GENERAL CONSTRUCTION NOTES

# C1.0

KITTRICK PLACE STREET  
IMPROVEMENT PLAN

DAELYN DRIVE &amp; SOPHIA LANE DETAIL GRADING

SOPHIA LANE (STREET D - CUL-DE-SAC)  
STA: -0+25 - 3+50 SCALE: H: 1"=30' V: 1"=3'

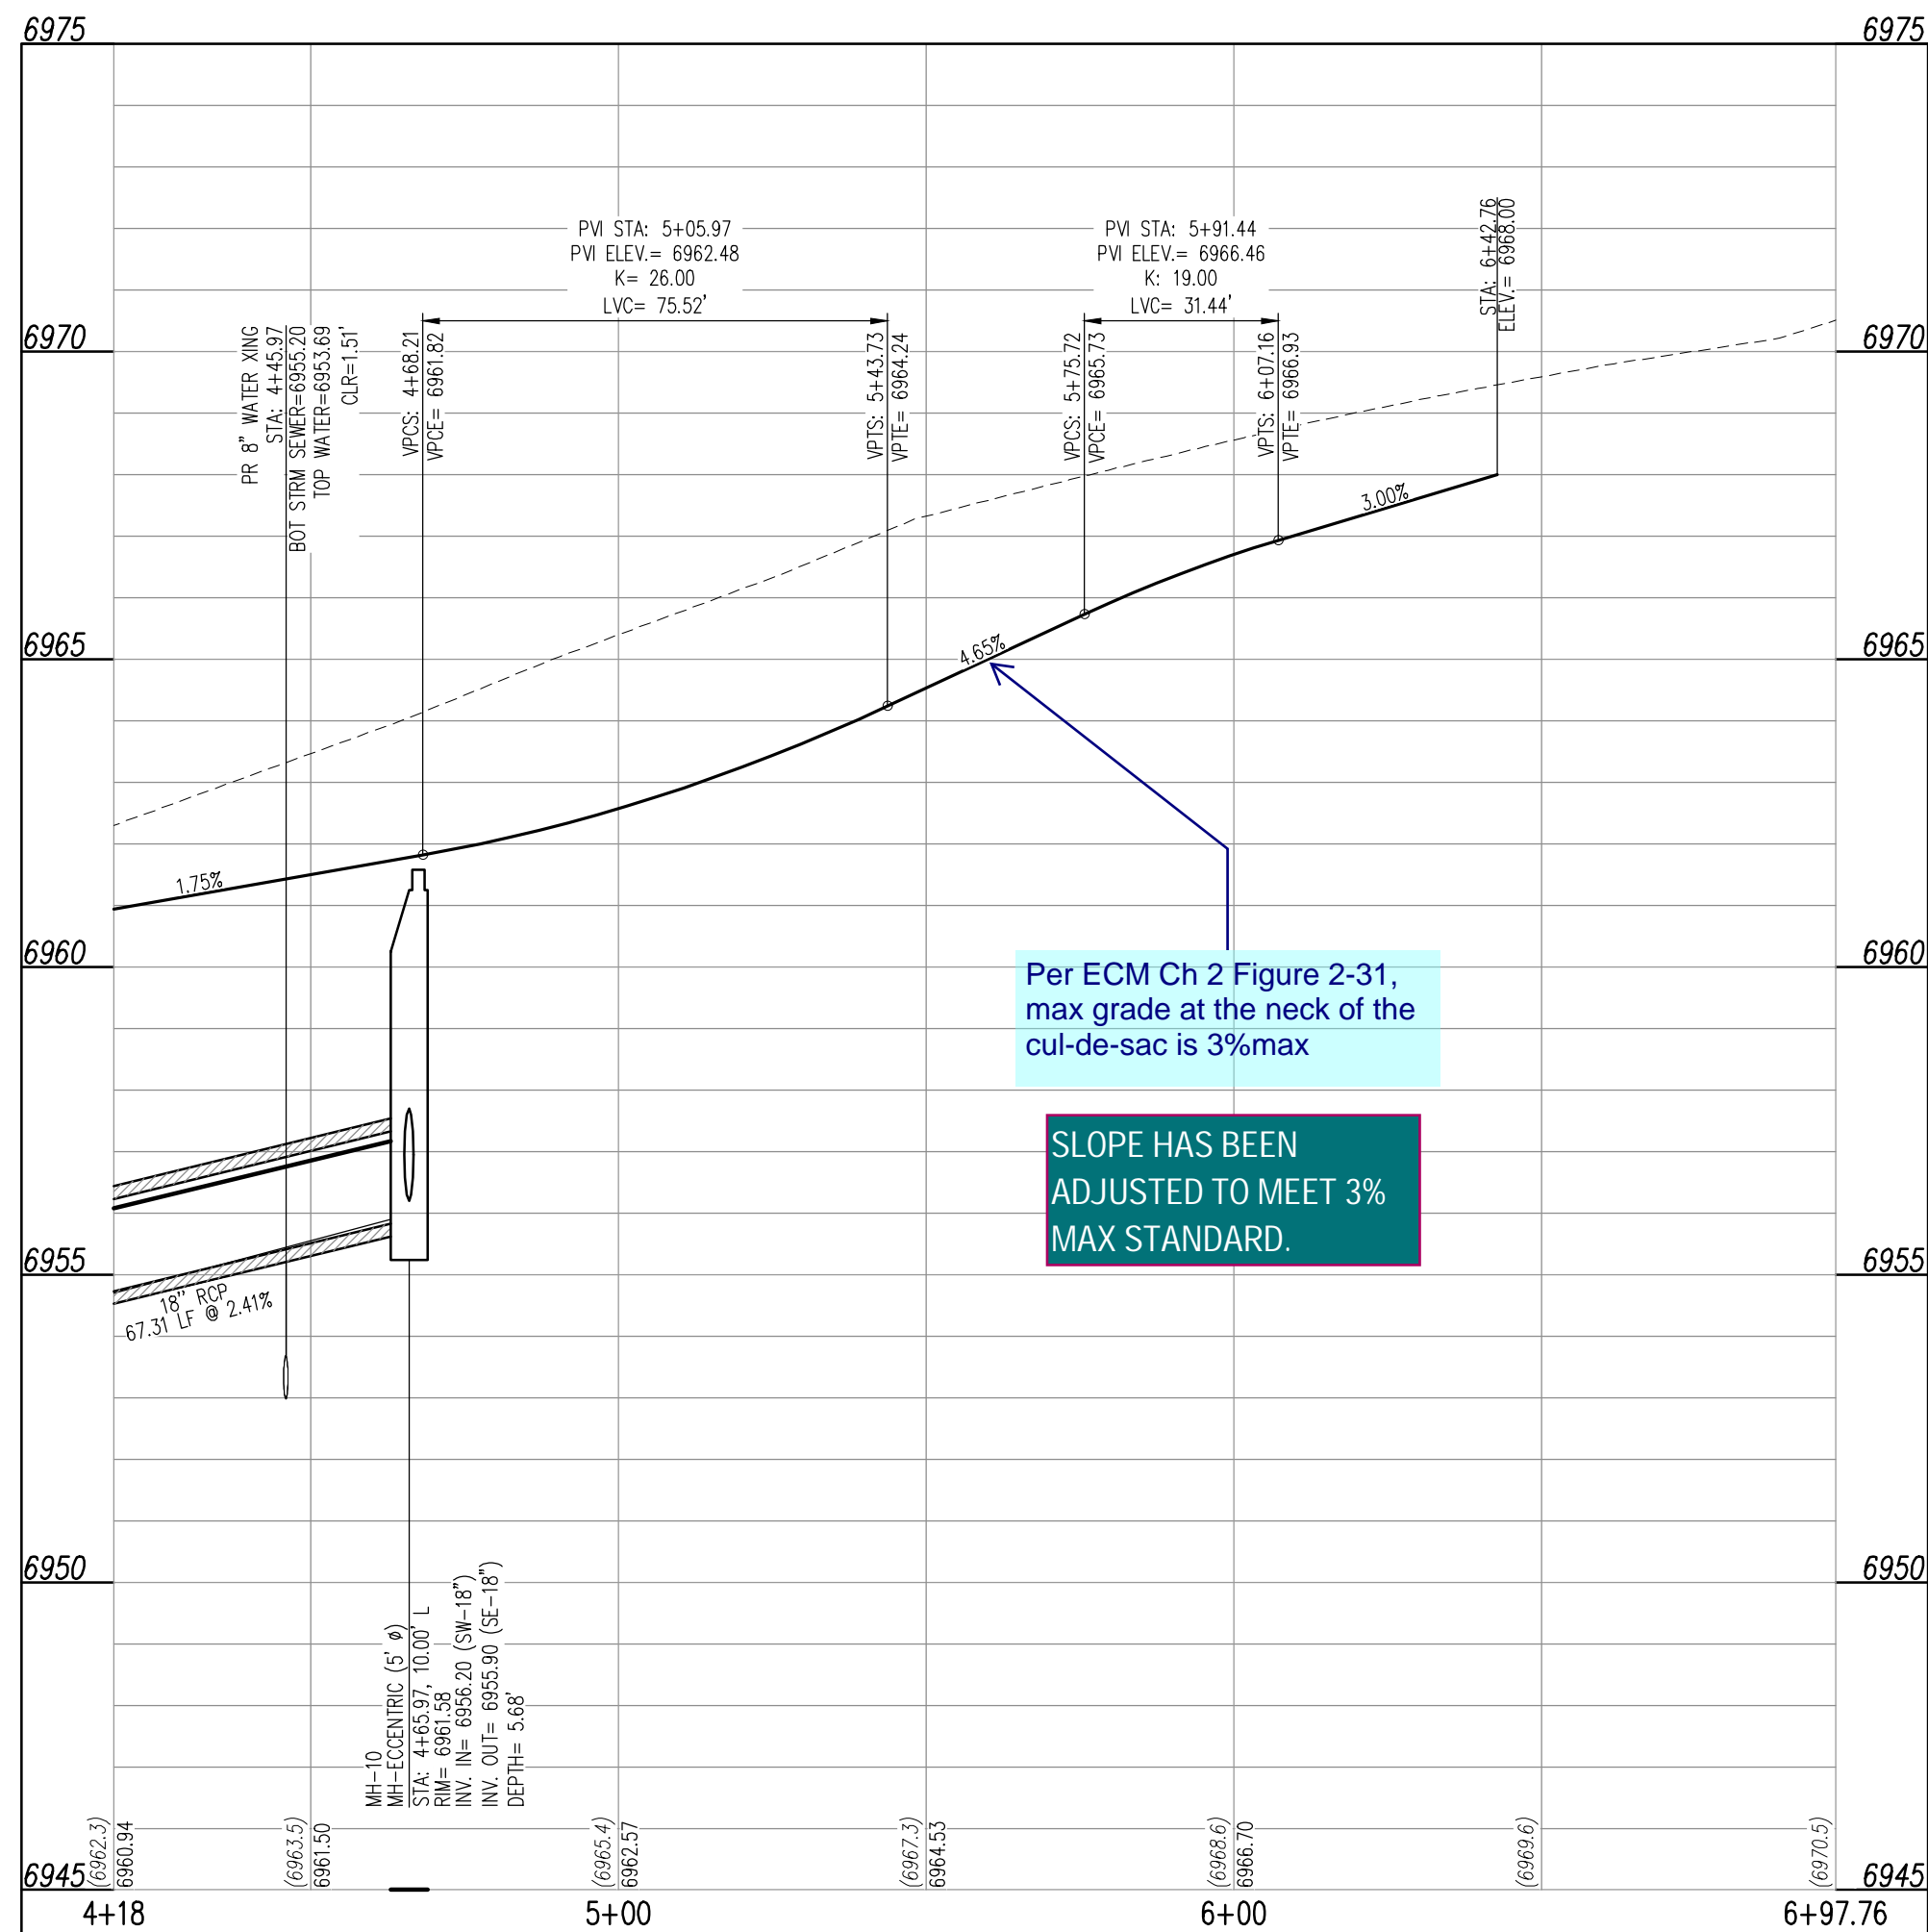
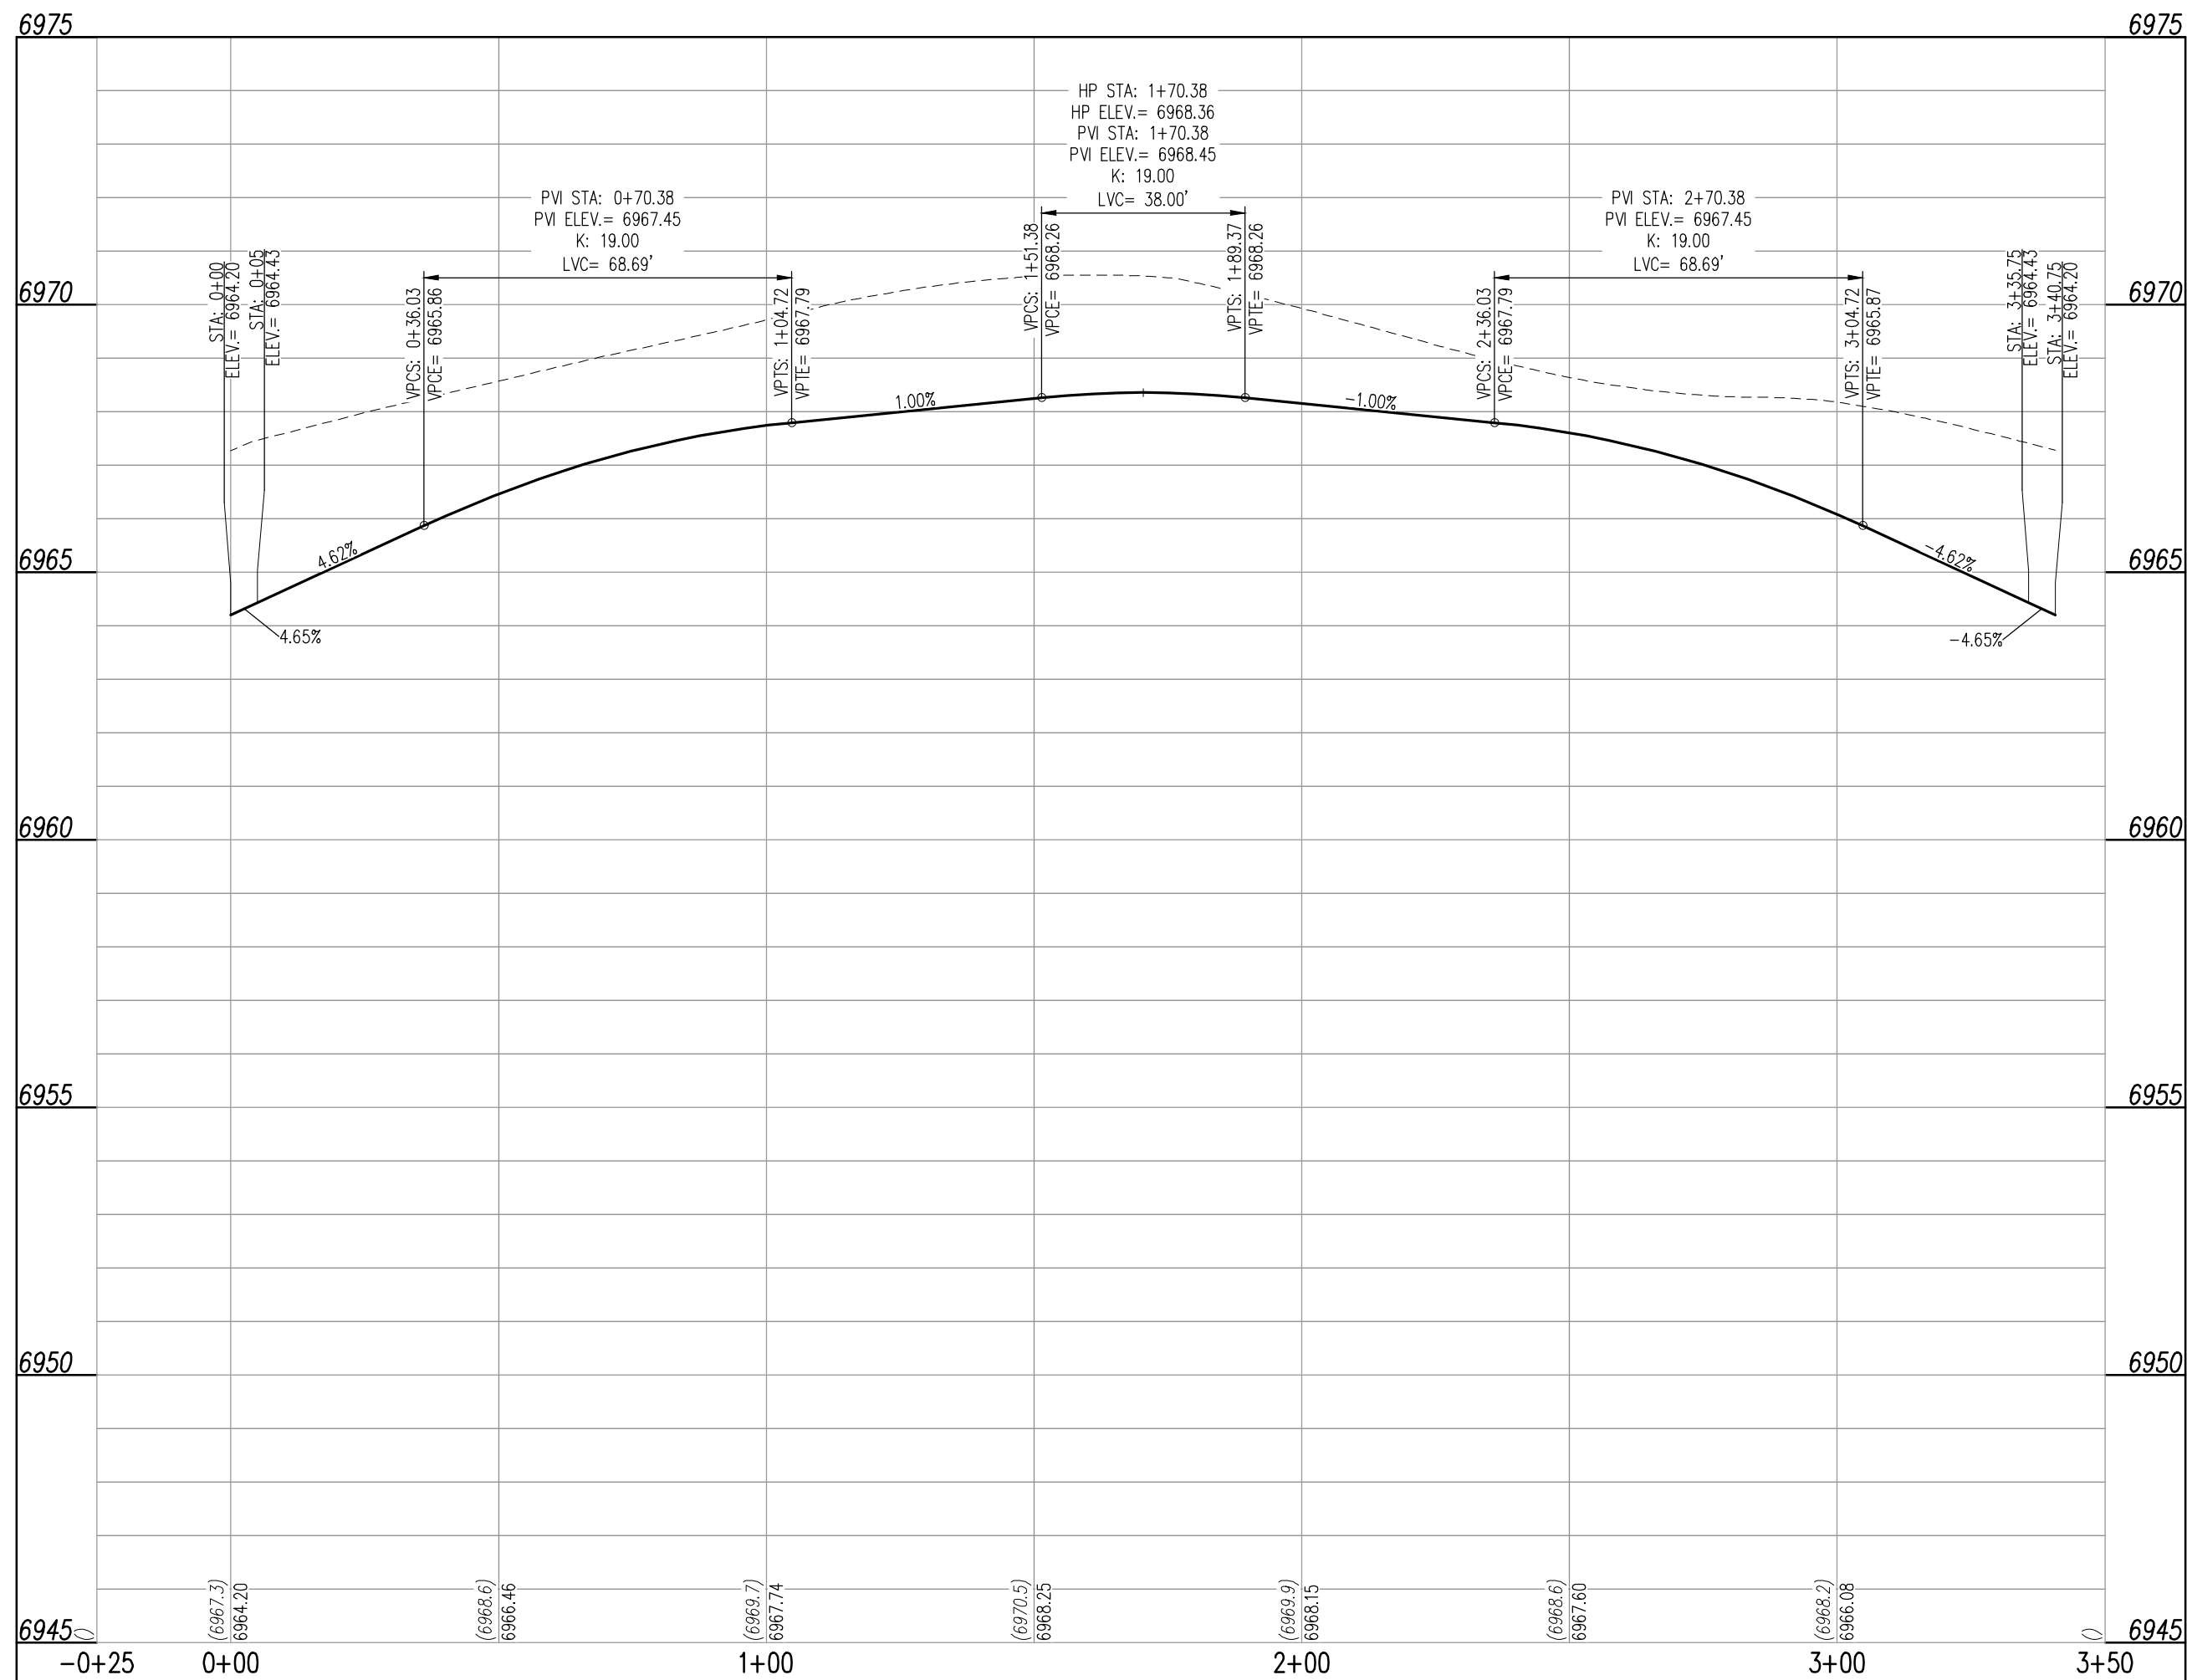
Please show the slopes at the cul-de-sac bulbs

Per EPC standard  
detail SD\_2-75 min.  
radius shall be 45'.  
revise accordingly.

Per ECM Ch 2 Figure 2-31,  
max grade at the neck of the  
cul-de-sac is 3% max

SLOPE HAS BEEN  
ADJUSTED TO MEET 3%  
MAX STANDARD.

DETAIL: UTILITY SERVICE LOCATIONS N.T.S.

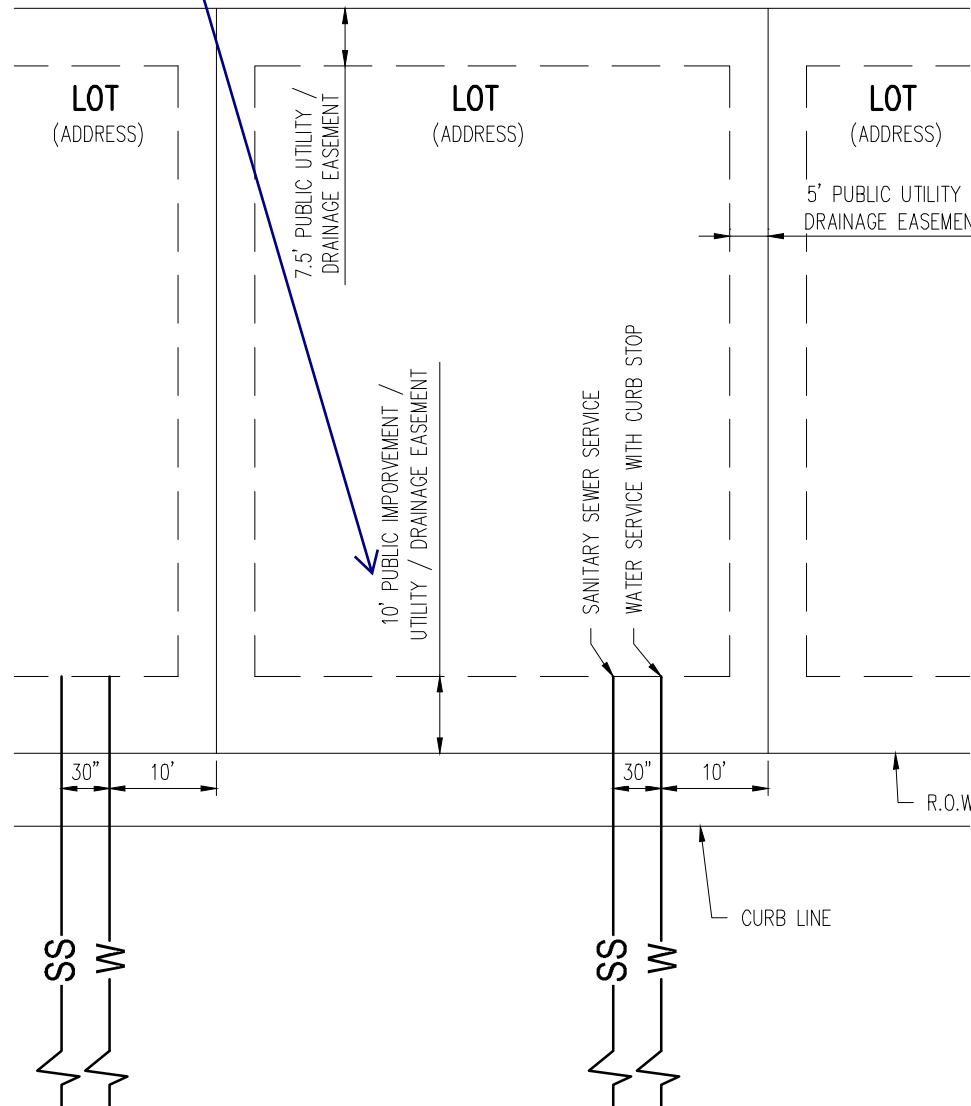
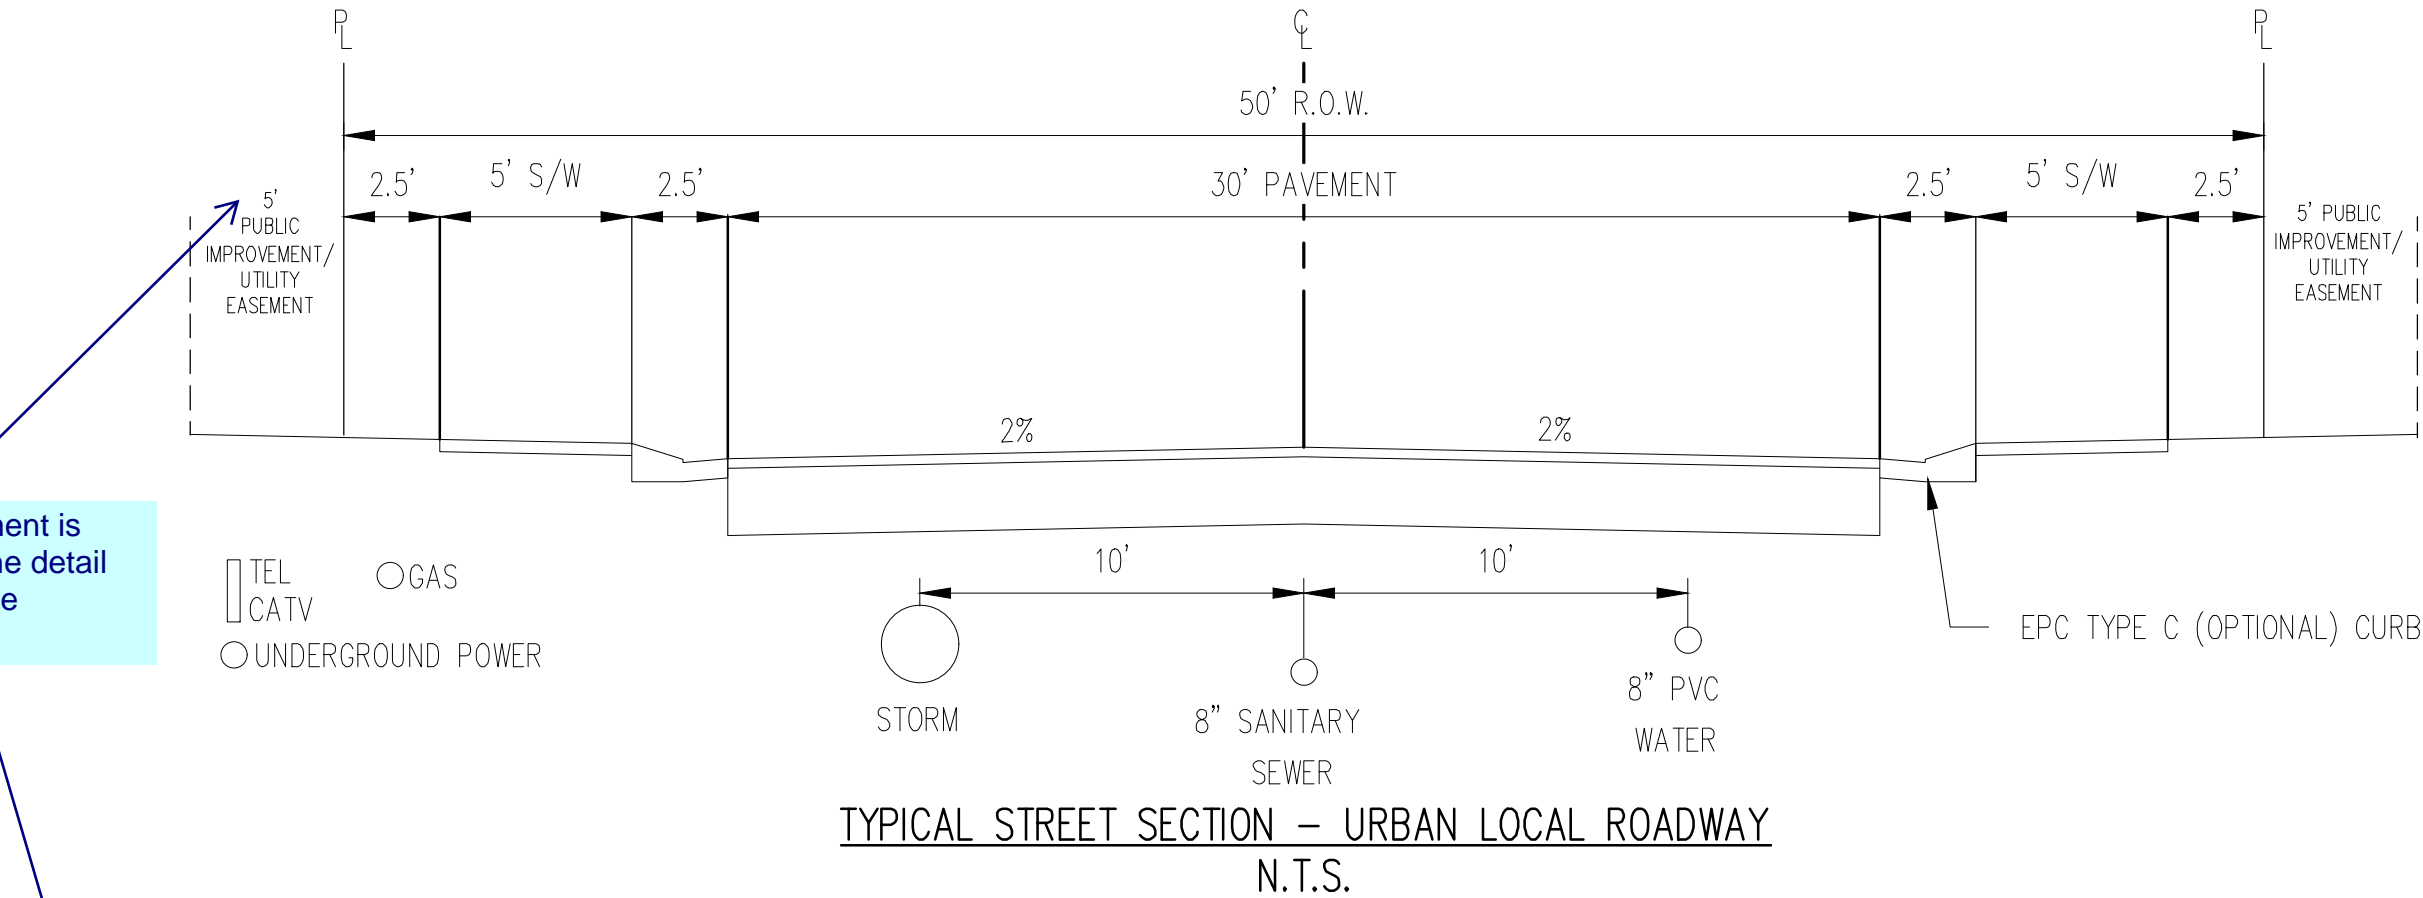
a 10' easement is shown on the detail below, revise accordingly.

ASSEMBLY IS UPDATED TO DISPLAY 5' UTILITY EASEMENT AND 10' MVEA EASEMENT -- THE ASSEMBLY MATCHES THE DETAIL
